MANDATORY SERVICE BULLETIN

MSB 42-137/1

MSB 42NG-079/1

Inspection of rudder T-yoke axle nut for looseness.

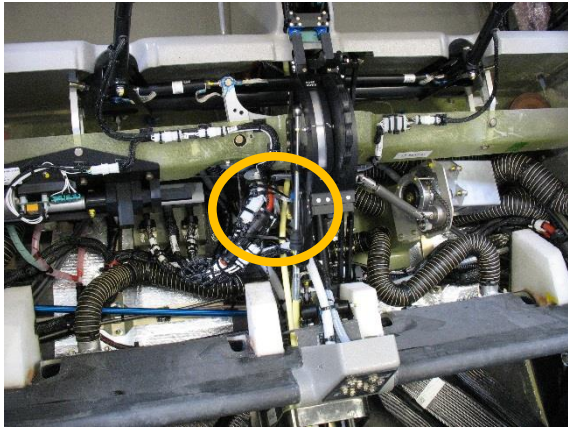
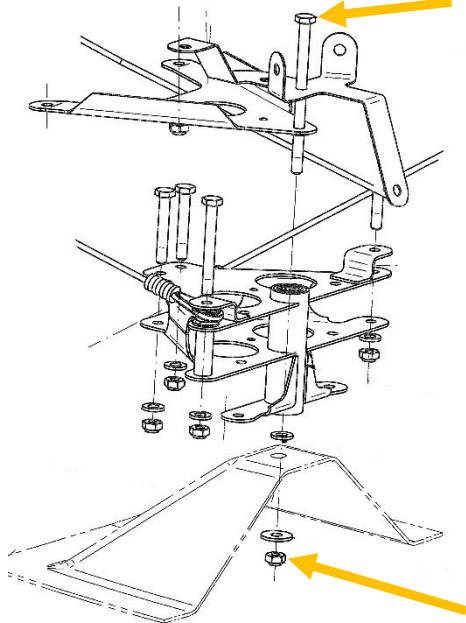
1	Remove the pilot and copilot seat in accordance with AMM Section 25-10.
2	Remove the middle tunnel front cover in accordance with AMM Section 25-10.
3	<p>Check the self-locking nut for correct torque:</p> <ul style="list-style-type: none"> • Block the self-locking nut with a ring-wrench. • Apply a torque of approx. 6 Nm to the head of the T-yoke axle.

4	<p>If the T-yoke axle can be rotated more than one half turn or if the nut is loose:</p> <ul style="list-style-type: none"> • do a condition inspection in accordance with AMM and MSB 42-087 / MSB 42NG-016, • correct any deficiencies, • replace the self-locking nut with a new self-locking nut.
5	Install the middle tunnel front cover in accordance with AMM Section 25-10.
6	Install the pilot and copilot seat in accordance with AMM Section 25-10.
7	Clean working area and check for foreign objects.
8	Perform functional check of altered, repaired and new parts.
9	Test all systems in working area for function.
10	Make necessary entries into aircraft logs.
